Omaha Public Power District

LIC-82-224

Control of Heavy Loads

Comments to FRC's

FIGURE 1

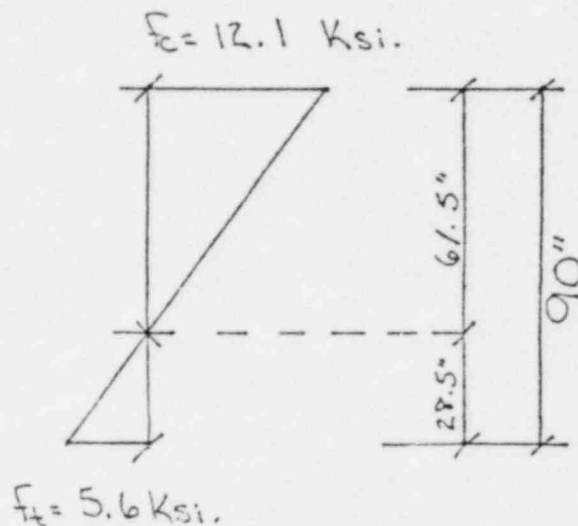
1. Nonsymmetrical girder sections were not used.
2. Any longitudinal stiffeners in use conform to the requirements of CMAA-70 and allowable h/t ratios in box girders using these stiffeners do not exceed those specified in CMAA-70.

GSE TASK ES-81-04
CALCULATED BY A. NALDA
CHECKED BY Jon Manure
SUBJECT Control of Heavy LoadsDATE 1-7-82
SHEET NO. 8 OF 11
REFERENCE CMAA-70, Harrischfeger
REVISION _____b) h/t ratio

$$\text{Requirement } h/t \leq C(k+1) \sqrt{\frac{17.6}{f_c}}$$

$$C(k+1) \sqrt{\frac{17.6}{f_c}} = 162(1+.462) \sqrt{\frac{17.6}{12.1}} \\ = 286$$

$$\text{Our provided } h/t = \frac{90 \times 8}{3} = 240 \\ t = 3/8"$$

Conclusion: Provided $240 < \text{Max. Allow.}$

Therefore meets CMAA-70 criteria
See Figure 1
